CONSERVATION COMMISSION AGENDA

March 2, 2021 @6:00 pm
Virtual Meeting

AREA 2
SCALE: 1" = 10'

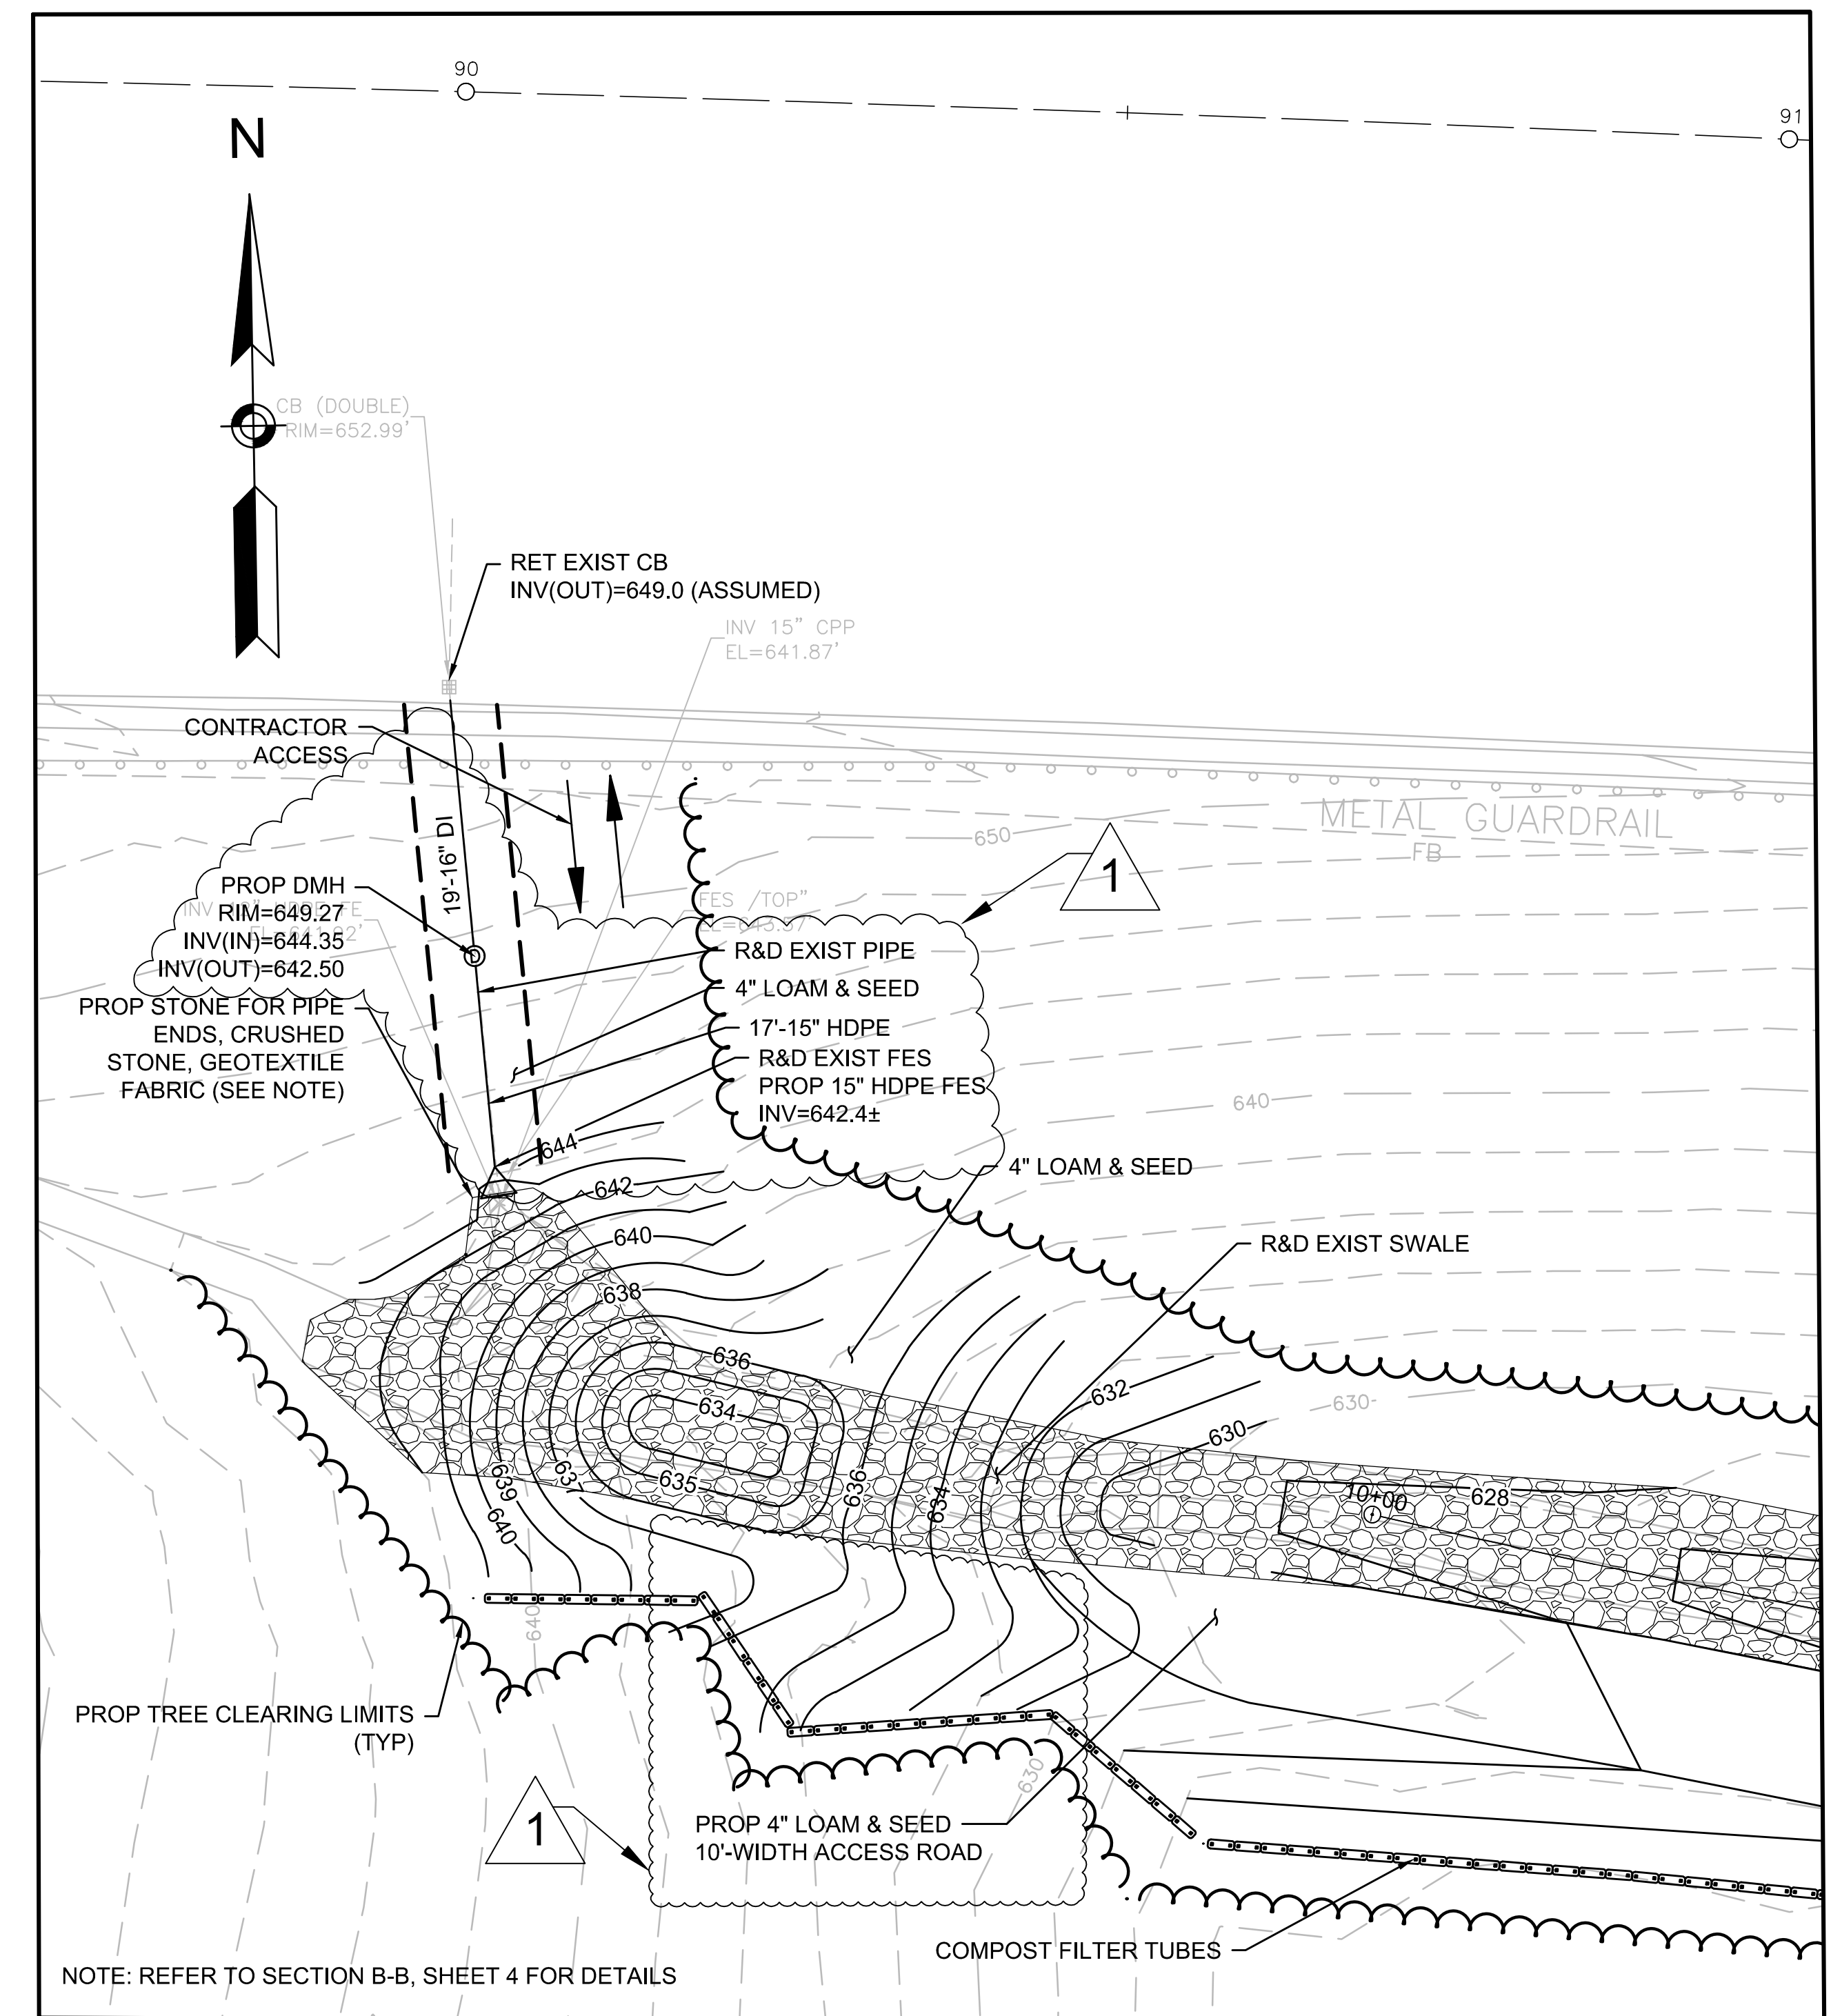
- Staff Notes:
 - The plan includes: full repair of the eastern swale, Area 5 on the plan, as requested; additional notes for work within Area 4 as requested; additional BMP improvements within Areas 2, new Area 6 and stations as shown on the plan. These BMP improvements (drop inlets, stilling wells, etc.) would appear to assist with treatment and velocity of storm-water.

- Staff spoke to CLA representatives and are pleased with modifications.
 - Staff Recommendations: Staff recommends that MA DOT provide a timeframe for implementation of the project changes. Will this affect the timeline provided? Approve plan as shown w/ the following notes. Staff recommends that all disturbed areas are seeded (w/ native seed mixes) and remain protect with erosion controls until the areas are stabilized. SCC shall be notified when work within each area is completed. Completed work should be reviewed by designing engineer and letter of substantial compliance (detailing any project variations) submitted at end of the project. Residents near Area 5 should be notified of work by DOT. Trees should be added to screen the residence near Area 5. Follow up monitoring of the implemented work should be conducted to ensure the improvements are functioning as designed. EO shall not be released until monitoring and documentation of completed and functioning project.
